To: Plan Holders for Improvements to the
Rosecrans Memorial Aiport
St. Joseph, Missouri
MoDOT Project No. 13-012A-2
Air National Guard Project No. ULYB132006

Transmitted herewith is Addendum **No. 4** to the Issued for Bid Contract Documents, Specifications and Plans dated June 23, 2015 for Improvements to the Rosecrans Memorial Airport.

Schedule I: Replacement of Assault Strip Runway 13/31

**ADDENDUM NO. 4
TO
CONTRACT DOCUMENTS, SPECIFICATIONS AND PLANS
FOR IMPROVEMENTS TO THE
ROSECRANS MEMORIAL AIRPORT
ST. JOSEPH, MISSOURI
MODOT PROJECT NO. 13-012A-2
AIR NATIONAL GUARD PROJECT NO. ULYB132006**

CONSTRUCTION SAFETY DRAWING -
SCHEDULE I, STAGE 2

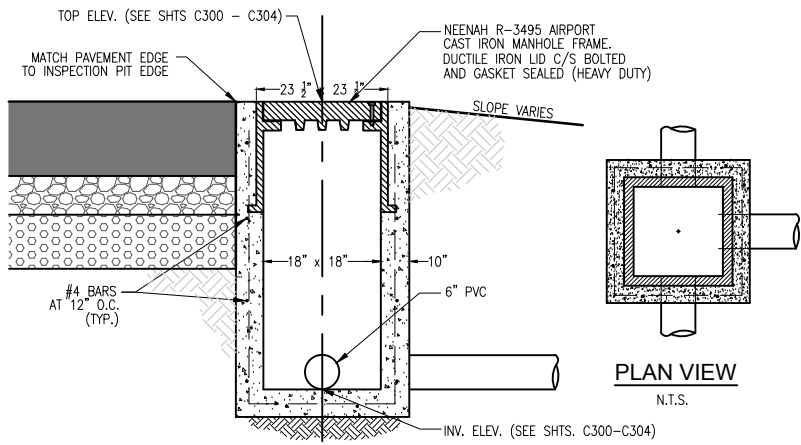
Sheet: G008
Title: Construction Safety Drawing – Schedule I, Stage 2
Revision: AIRPORT OPERATIONAL NOTES
Delete Note No. 2 in its entirety and replace with the following revised Note No. 2:
“CONTRACTOR SHALL RE-ESTABLISH THE RUNWAY SAFETY AREA PRIOR TO THE OPENING OF RUNWAY 17/35. THE CONTRACTOR WILL INCUR A \$1,500 LIQUIDATED DAMAGE IF RUNWAY 17/35 IS NOT OPENED BY 6:00 A.M. AND AN ADDITIONAL \$1,500 FOR EACH HOUR THAT RUNWAY 17/35 REMAINS CLOSED AFTER 6:00 A.M. THE REMOVAL OF THE LIGHTED “X”s AND BARRICADES SHALL BE COMPLETED PRIOR TO REOPENING THE RUNWAY.”
See attached revised sheet G008.

5 PAVEMENT UNDERDRAIN DETAIL
C350
N.T.S.

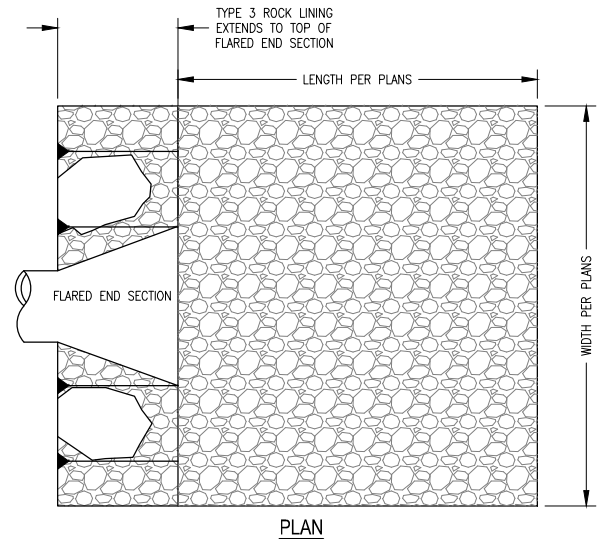
Sheet: C350
Title: Storm, Underdrain and Erosion Control Details
Revision: DETAIL “PAVEMENT UNDERDRAIN DETAIL”
Delete the overbuild call-off note in its entirety and replace with the following revised note:
“7” OVERBUILD OF 6” AGGREGATE BASE COURSE FOR PAVEMENT SECTION.”
See attached revised sheet C350.

E
C200 - C204
TYPICAL SECTION E
STA 10+00 TO 12+50
(TRANSITIONING CROSS SLOPE),
STA 12+50 TO 56+00
(1.50% CROSS SLOPE)
N.T.S.

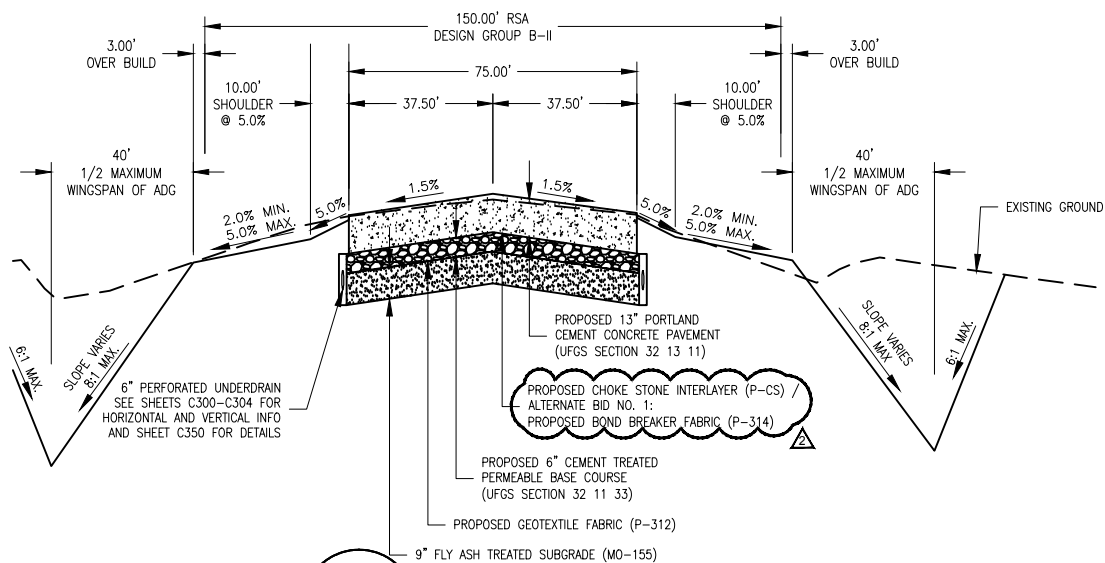
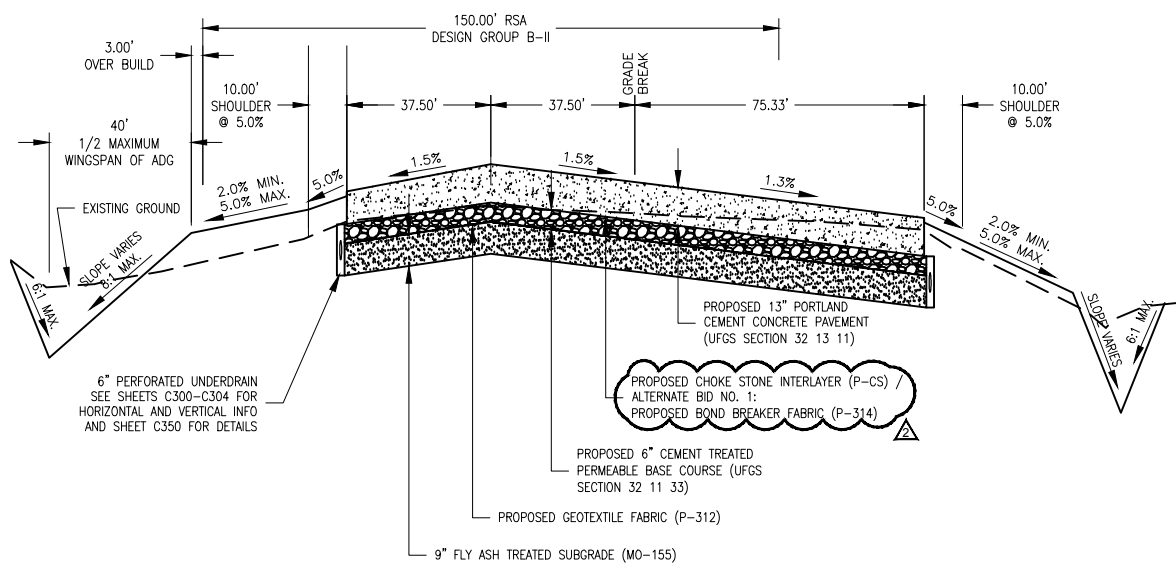
Sheet: C601
Title: Proposed Typical Sections
Revision: Revised the Bond Breaker call-offs on Typical Sections E and F to include:
“Alternate Bid No. 1: Proposed Bond Breaker Fabric (P-314)”
See attached revised sheet C601.
